Urgent Field Safety Notice

CHC16-09.A.OUS

ADVIA® Chemistry Systems

Chemistry Calibrator Reassignment for the ADVIA® Chemistry Direct Bilirubin Assay (DBIL_2)

Figure 1. Patient sample correlation of the Direct Bilirubin Assay (DBIL_2) and bias plot before and after calibrator value reassignment in mg/dL

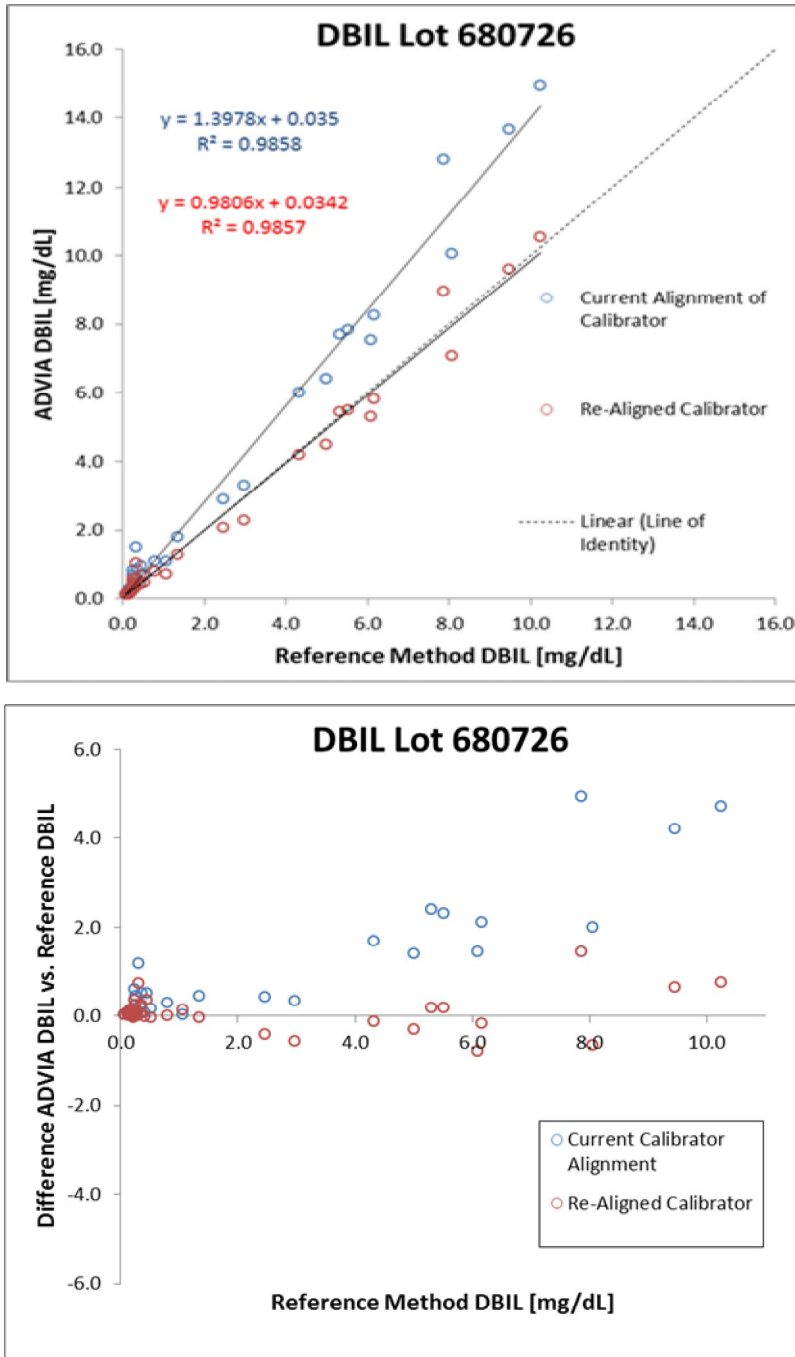
A representative correlation of DBIL_2 before and after calibrator value reassignment using patient samples can be seen in Figures 1 and 2 below. Figures 1 and 2 demonstrate that after reassignment of the DBIL_2 calibrator value for Chemistry Calibrator Lots 680726 and 680726 A through D, the bias is corrected and DBIL_2 recovery is aligned to the reference method.
